DAWN MINING COMPANY, LLC
P.O. BOX 250
5326 Uranium City Road
Ford, Washington 99013

July 5, 2011

**Re: Revised Proposal for Disposal for Midnite Mine Water Treatment Plant
Solids in Tailings Disposal Area 4**

Figure 5
 Schematic Layout of MMWTP Solids and Millsite Materials Disposal Areas

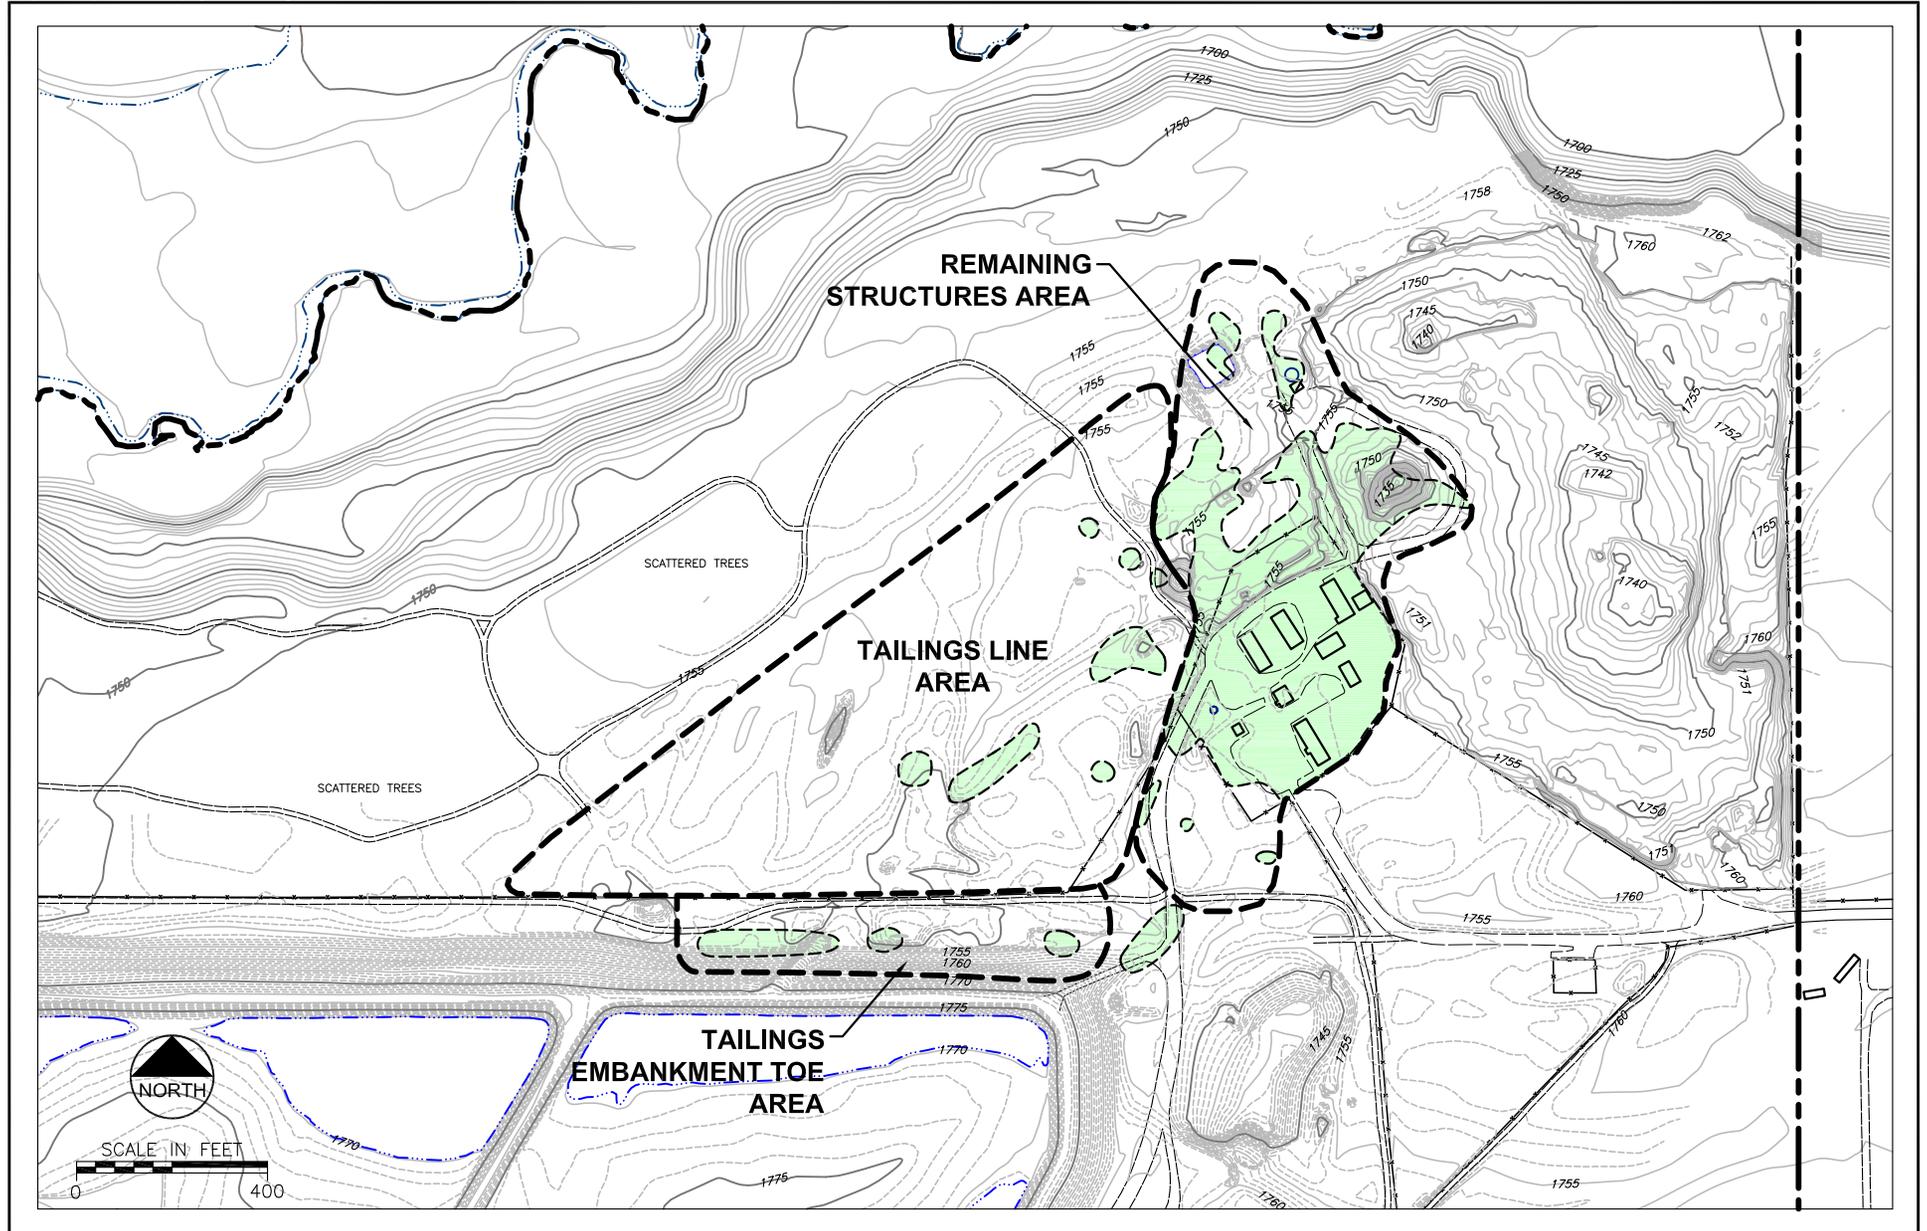
- Section 6.0 - DMC needs to provide a figure that shows the approximate lateral extents (footprint) of remaining millsite-contaminated materials (soils and demolition debris). Work plans for millsite demolition debris and associated materials, remaining contaminated soils, and evaporation pond residues will need to be submitted for DOH review and approval prior to placement in TDA-4.

DMC Response: Figures showing the approximate lateral extent of the location of disposal of remaining millsite-contaminated materials in TDA-4 and the location of these materials in the millsite is included with DMC's License Amendment Application, Attachment A, as Figures 5 and 6 respectively. DMC will provide work plans for millsite demolition debris and associated materials, remaining contaminated soils, and evaporation pond residues for WDOH review and approval prior to placement of those materials in TDA-4.

Figure 18a-1.1
Schematic Layout of Area of Material Disposal

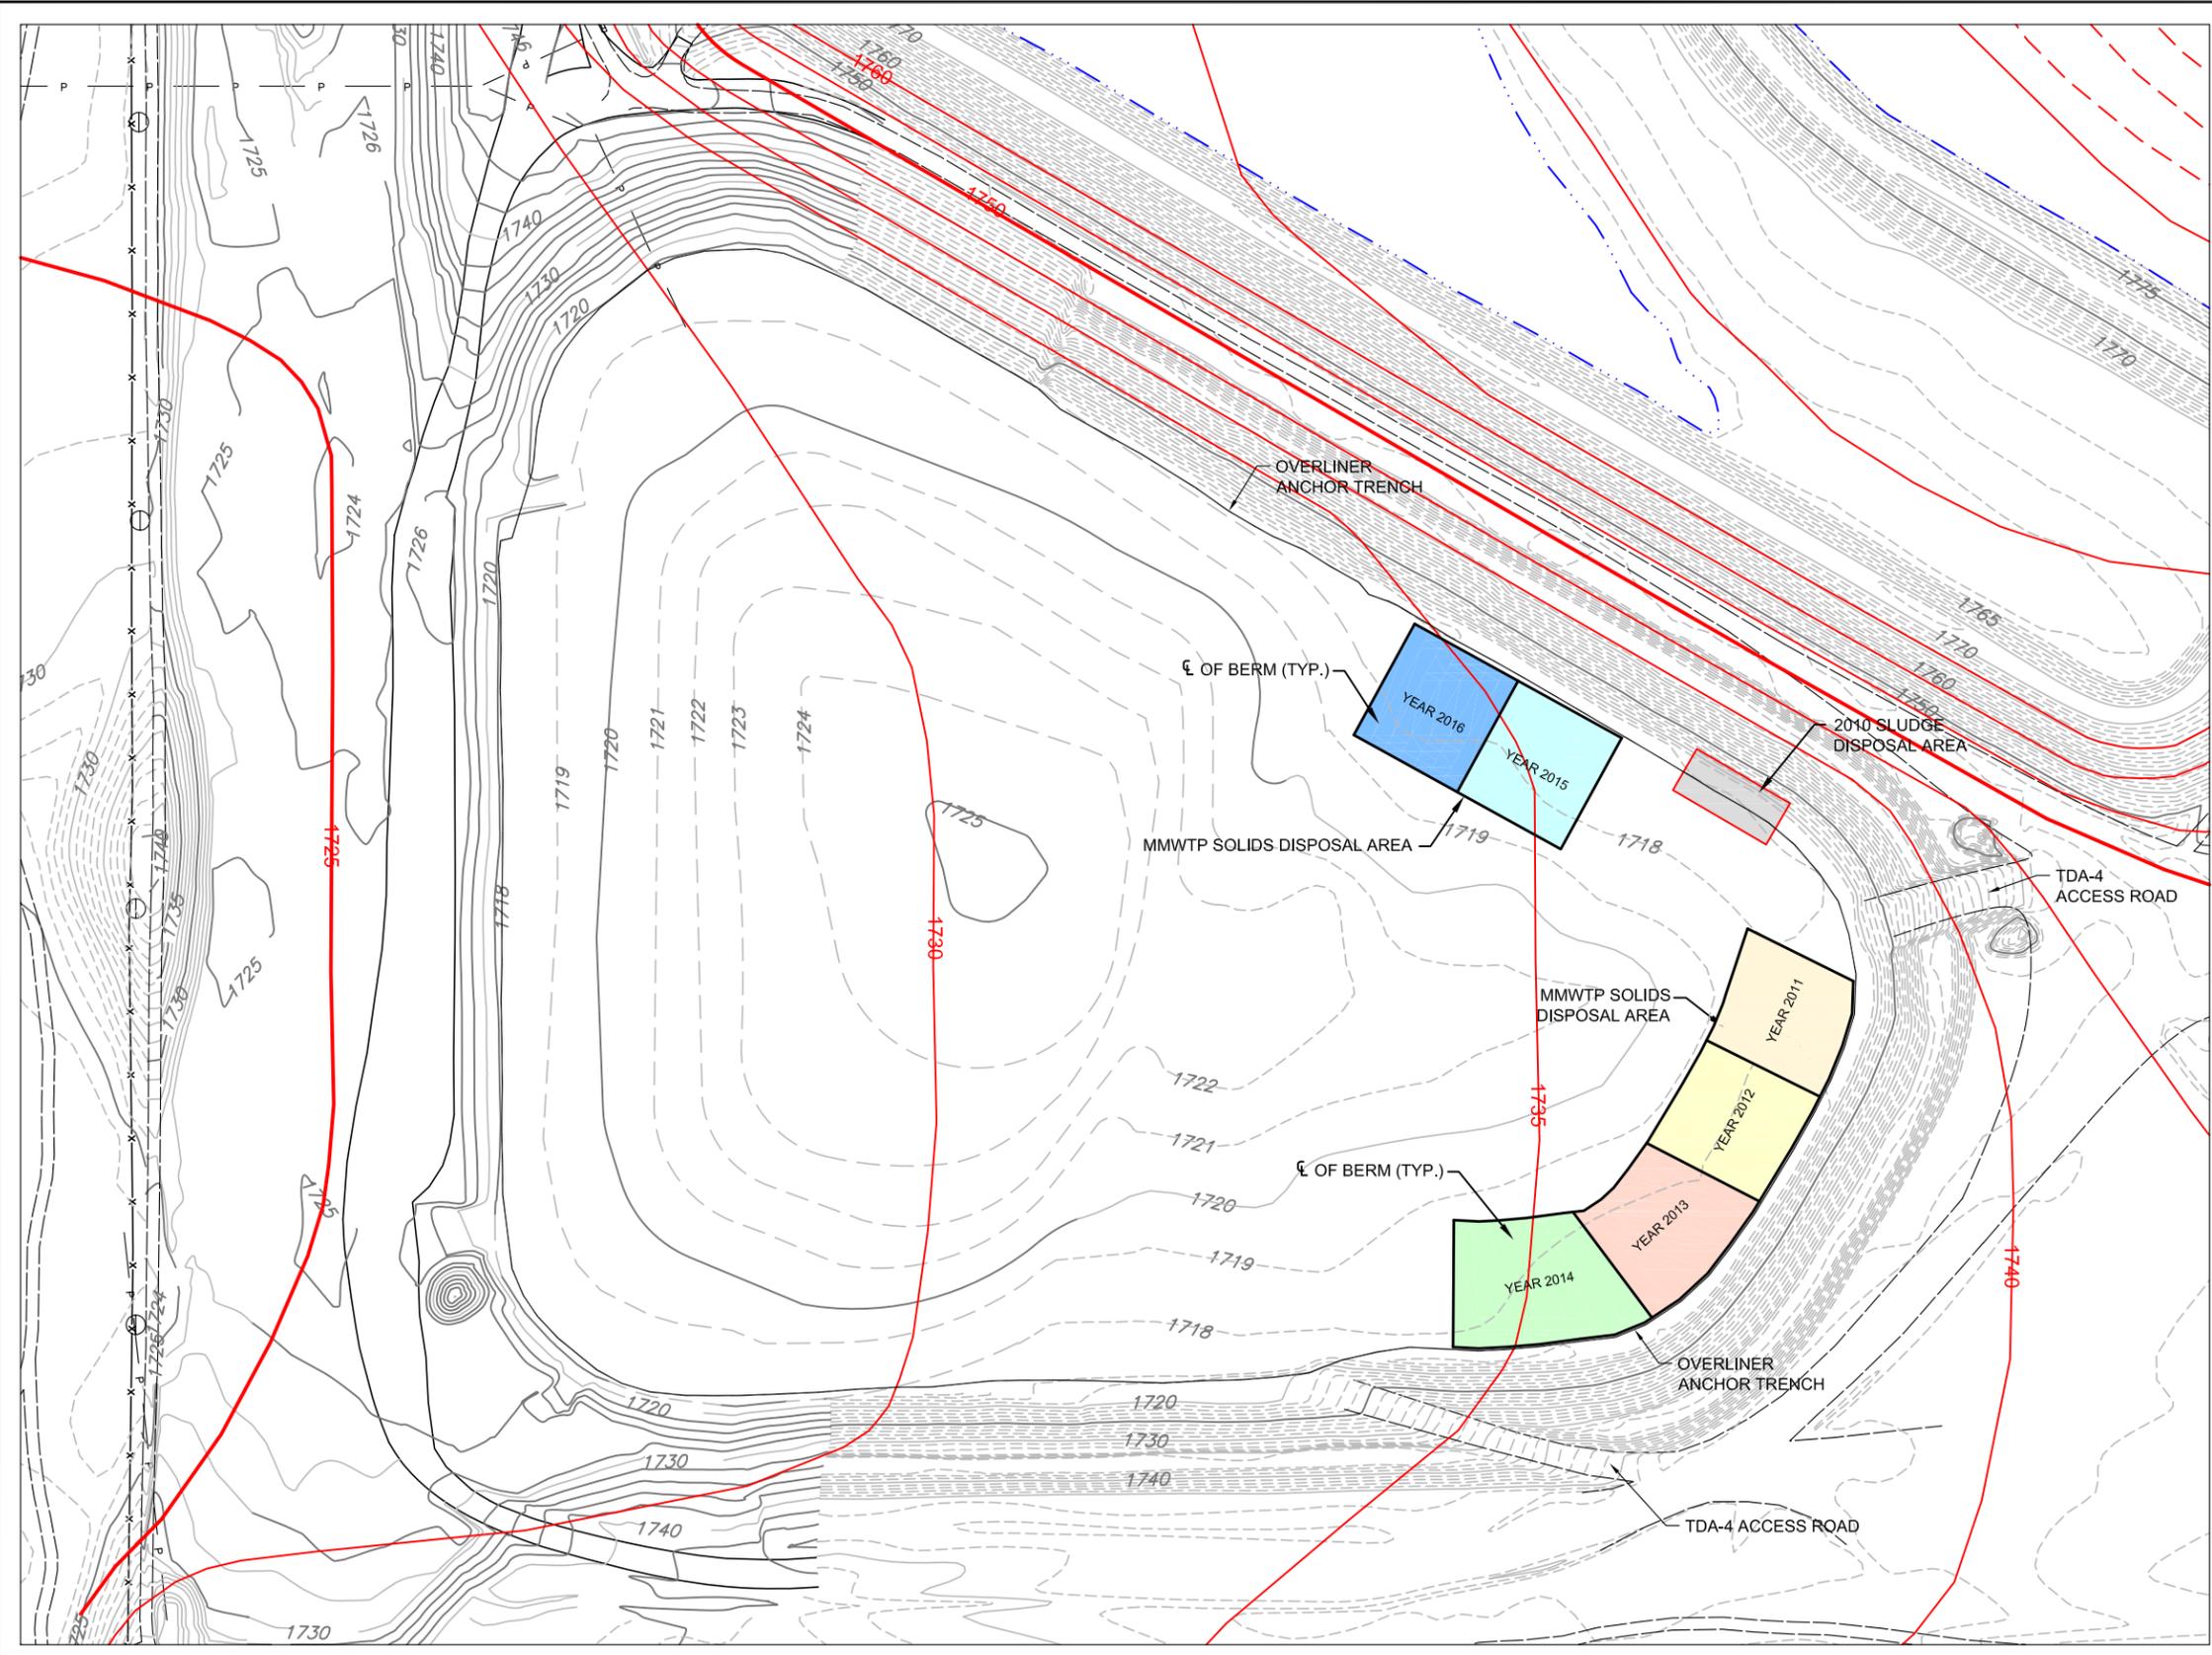
- Figure 18a-2.1: Add soil cover over 40-mil HDPE and plan view showing disposal cell sequencing.

DMC Response: DMOP 18a has been revised accordingly. See DMOP 18a, Attachment 18a-1, Figure 18a-1.1.
